Supplement 28/24

A D: SEOUL/Incheon INTL(RKSI)

RWY 15L/33R AND TWYs CLOSED DUE TO CONSTRUCTION

2. CLOSED AREAS & PERIOD (See the diagram)

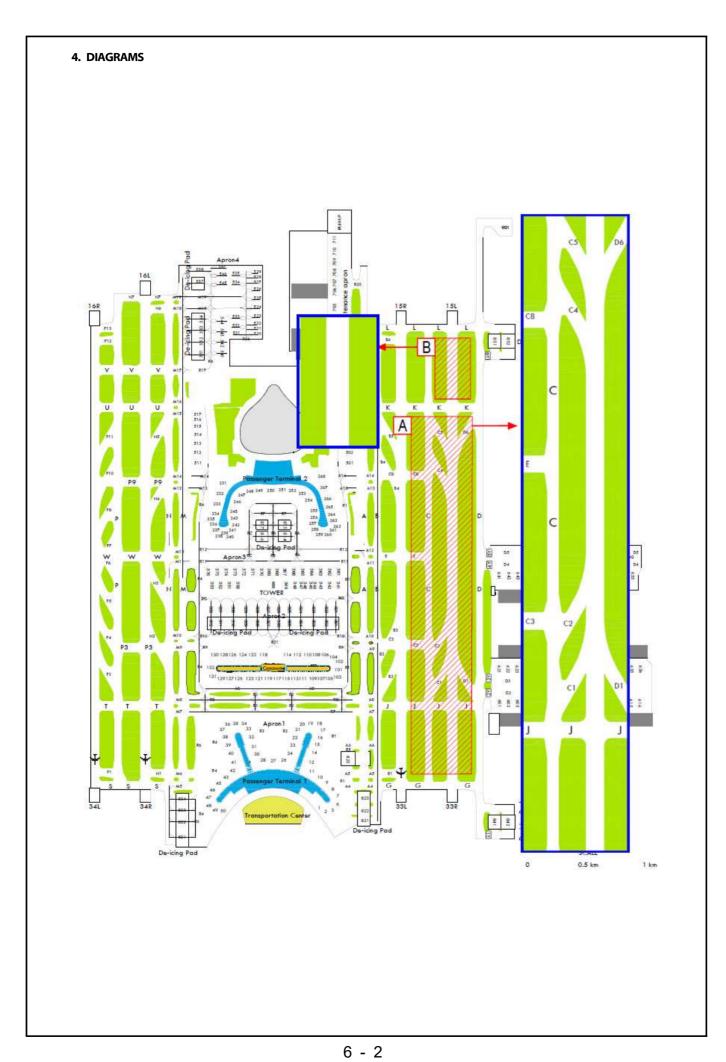
- (1) RWY 15L/33R will be closed due to pavement construction.
- (2) Some parts of TWY C and TWY J will be closed due to pavement construction.

Closed Areas		Period(UTC)
А	RWY 15L/33R between TWY G and K ** No effect on TWY G and K operation.	From 1600 UTC 12 JUN 2024 To 0300 UTC 8 AUG 2024
	TWY C between TWY G and K	
	TWY J between RWY 15R/33L and TWY D ** No effect on RWY 15R/33L and TWY D operation.	
	Rapid exit TWY C1, C2, C4, C5	
	Rapid exit TWY D1, D6	
В	RWY 15L/33R between TWY K and TWY L	From 1600 UTC 12 JUN 2024 To 0300 UTC 8 AUG 2024

- (1) RWY 15L/33R and TWYs will be closed as shown in the diagrams.
- (2) Unserviceable lights and frangible barriers will be installed on the closed areas.

Arrival for RWY 15L/R, 16L/R

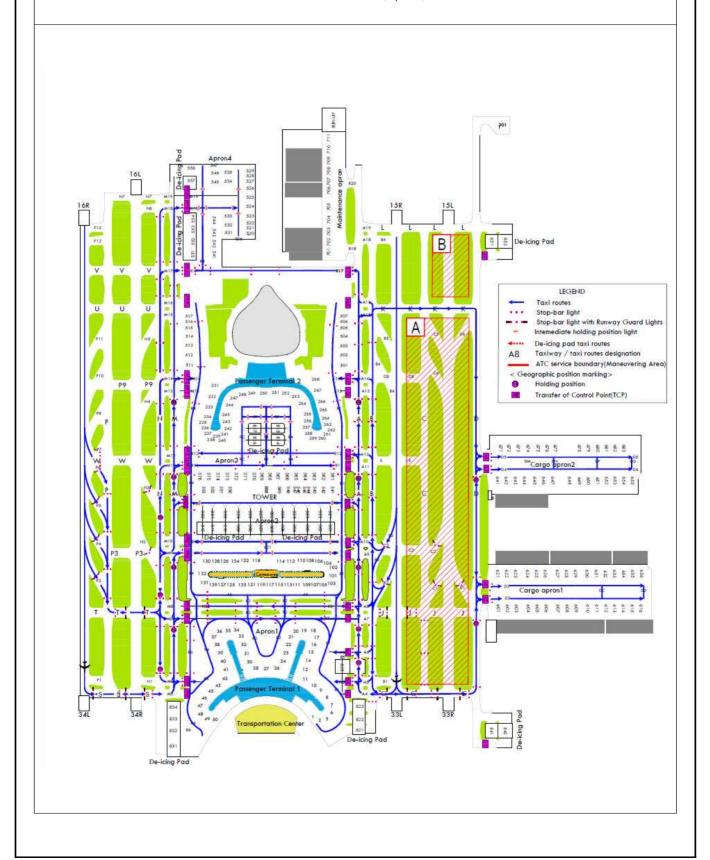
- (4) Some parts of sandard taxi routes(AIP RKSI AD CHART 2-6, 2-7, 2-8, 2-9) and low visibility procedures (AIP RKSI AD 2-29, 2-30, 2-31, 2-32) will be temporarily changed due to the construction.

- (5) Temporary taxi routes may be changed by the ATC instruction.
- (6) TWY centerline lights, TWY edge lights, Stop bar lights and Taxiway guidance sign for the closed areas will not be operated.
